Access Compliance Report Public Rights-of-Way (Curb Ramps)

Intersection ID: 29427 Main Street: BRADSTREET_COMMONS_WY Cross Street: SHINY_MEADOW_LN Location: S

ADA ID: 5E582EB8D7A5 Ramp Type: Perp Initial Pass/Fail: Fail Overall Compliance: No Severity Score: 12.5

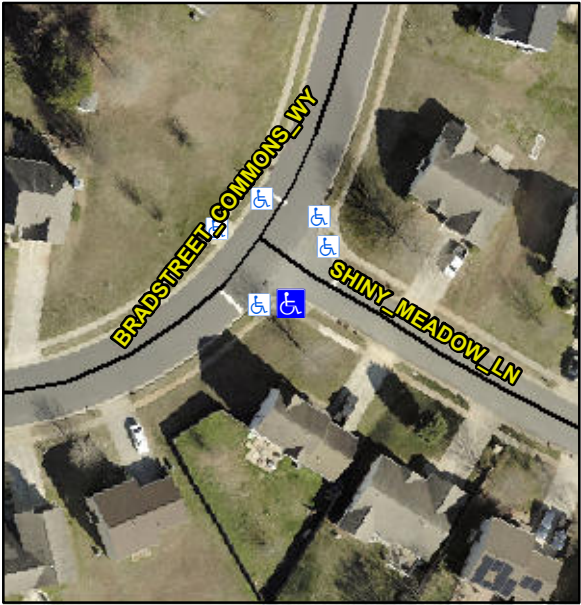
PROW/ADA:
Not Found, R304.2.2

Compliance	Description	Data	Compliance	Description	Data
N/A	Ramp Length (in)	48.0	No	Ramp Slope (%)	9.3
Yes	Ramp Width (in)	48.0	Yes	Ramp XSlope (%)	1.3
N/A	Flare Type LT	N/A	N/A	Flare Type RT	N/A
N/A	Flare Slope LT (%)	N/A	N/A	Flare Slope RT (%)	N/A
N/A	Flare Traversable LT?	N/A	N/A	Flare Traversable RT?	N/A
N/A	Landing Length (in)	N/A	N/A	DWS Provided?	N/A
N/A	Landing Width (in)	N/A	N/A	DWS Contrast?	N/A
N/A	Landing Slope (%)	N/A	N/A	DWS Length (in)	N/A
N/A	Landing X Slope (%)	N/A	N/A	DWS Full Width?	N/A
N/A	Landing Curb? (Y/N)	N/A	N/A	DWS Offset (in)	N/A
N/A	Shared Landing?	N/A			
N/A	Gutter Ponding?	N/A	N/A	Gutter Slope (%)	N/A
N/A	Gutter Lip Ht (in)	N/A	N/A	Gutter X Slope (%)	N/A
N/A	Painted X Walk1?	No	N/A	Painted X Walk2?	N/A
	X Walk 1 Direction	To NE		X Walk 2 Direction	N/A
N/A	X Walk 1 Width (in)	N/A	N/A	X Walk 2 Width (in)	N/A
	X Walk 1 Slope (%)	2.2		X Walk 2 Slope (%)	N/A
	X Walk 1 X Slope (%)	3.5		X Walk 2 X Slope (%)	N/A

Possible Solutions:
Remove & Replace Entire Ramp.
